FREDERICKSON ADVISORY COMMISSION (FAC)

Preliminary Plat – Berkeley Hills

Donna Rhea, Associate Planner donna.rhea@piercecountywa.gov

Plat Map – January 14, 2022

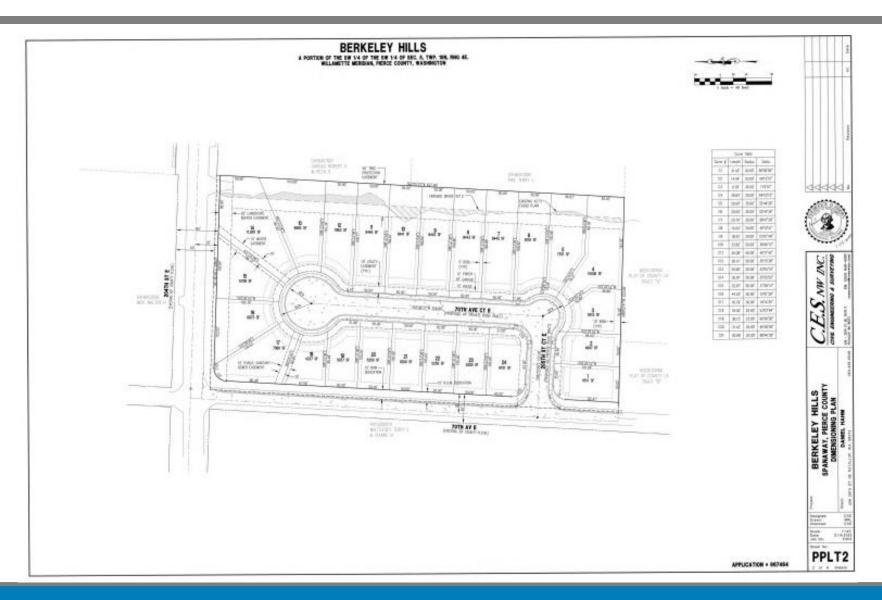
- The MSF zone classification has a minimum and base density of 4 du/acre with a maximum of 6 du/acre. Minimum lot size is 4,000 sq. ft. with a mean lot size of 5,000 sq. ft. The minimum lot width is 50-feet.
- Density is calculated on net developable acreage. The net developable acreage for this plat is 4.04 acres which meets the maximum density of 5.94 du/acre rounded up to 6. The number of lots may potentially be reduced with review of the requested flood study.
- Lot size has been met for the proposal.

Tree Inventory January 14, 2022

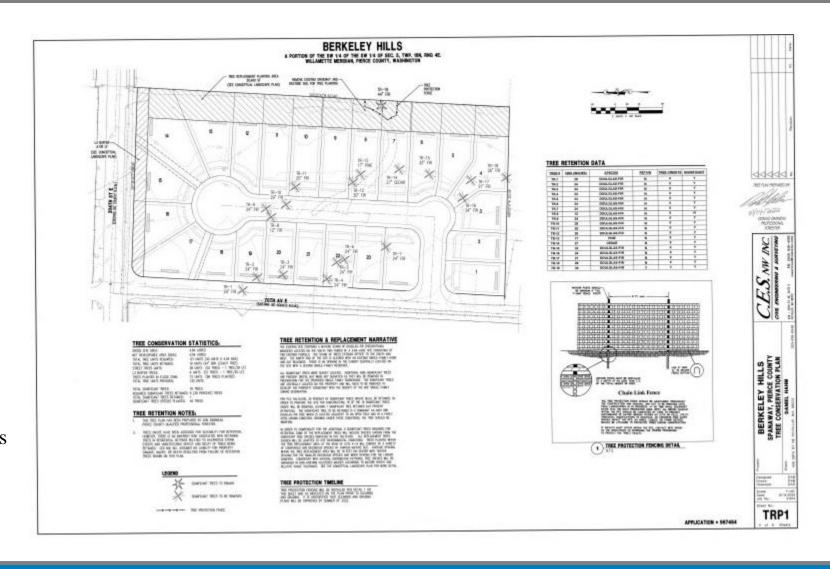
- The MSF zone classification requires that 30 tree units/acre of net developable acreage be provided along with retention of 30% of significant trees.
- The net developable acreage of 4.04 acres requires a total tree unit count of 121 tree credits. The submitted plan shows a total of 130 tree units which meets the requirement.
- 19 significant trees exist on the site which would require that 6 (30%) be retained.
- The current location of significant trees on the parcel would prohibit development of the plat so a Site Plan Review (SPR) is requested to retain 1 significant tree and plant 160 additional trees on the parcel.
- The Tree Conservation Plan is required to be completed by a Landscape Architect which has not yet been done. The plan is subject to change; however, staff will ensure that the intent of alternate design meets the code requirement.

Landscape Plan – January 14, 2022

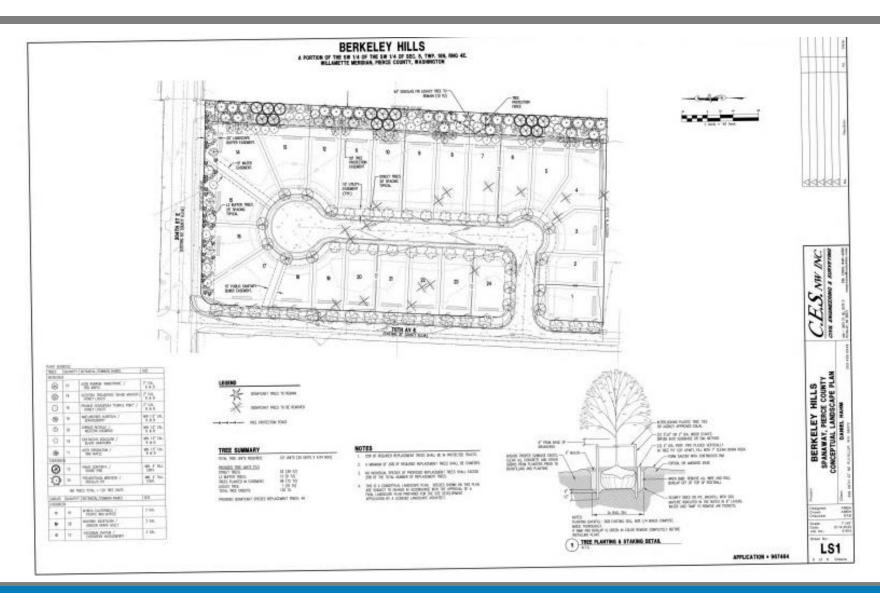
- The plat requires a 20-foot wide L3 landscape buffer along the northern property boundary abutting 204th St. E.
- A 50 ft. wide tree easement is proposed along the eastern property line; however, that may be subject to change upon review of the flood survey.
- Street trees at a rate of 1 tree per 30 lineal ft. are required to be installed along all new or improved right-of-way.
